Product Change Notification

Change Notification #: 823764-00

Change Title: 1600W Common Redundant Power Supply
FXX1600PCRPS (Platinum-Efficiency),
PCN 823764-00, Label, Product Design,
Updating PSU Components, Updating PSU Label
and Adding Certificate Marks

Date of Publication: May 31, 2024

Image 2. (1) Power supply label after the change for the TA # G44214-011.

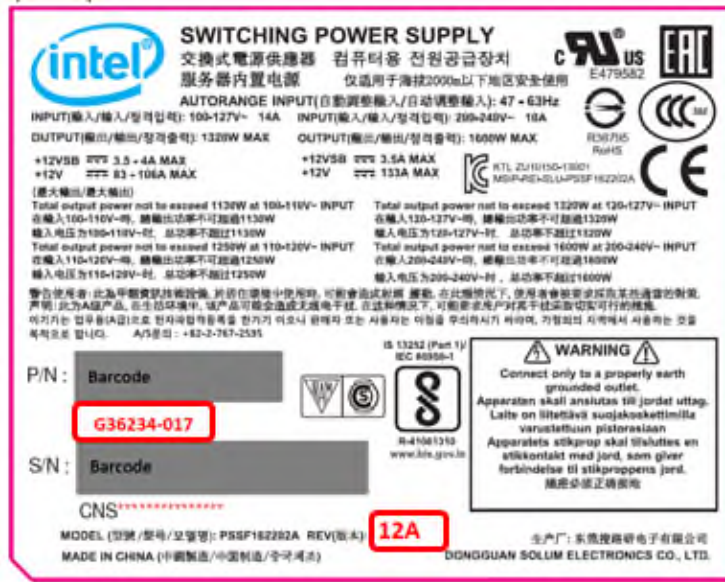
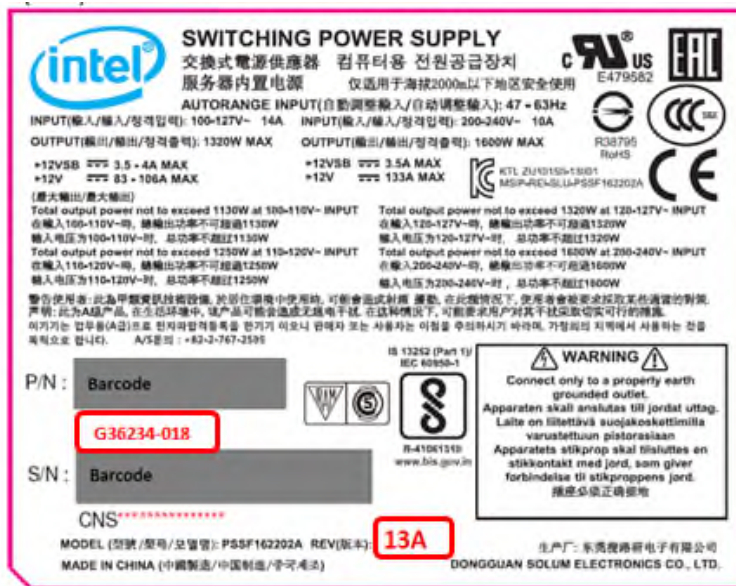
Power Supply TA	P/N	Changes implemented
G44214-010 to G44214-011 ⁽¹⁾	G36234-017 to G36234-018	<ul style="list-style-type: none">Resistor component replacement. There are no expected changes in function, size, or form.FW upgrade from 79.9.128 to 80.9.128
G44214-011 to G44214-012 ⁽²⁾	G36234-018 to G36234-019	<ul style="list-style-type: none">UKCA certificate logo updated in PSU label.Remove S&E from CCC logo in the PSU LabelFW Upgrade from 80.9.128 to 81.9.128
G44214-012 to G44214-013 ⁽³⁾	G36234-019 to G36234-020	<ul style="list-style-type: none">Line Filter Core component replacement. There are no expected changes in function, size, or form.FW Upgrade from 81.9.128 to 82.9.128
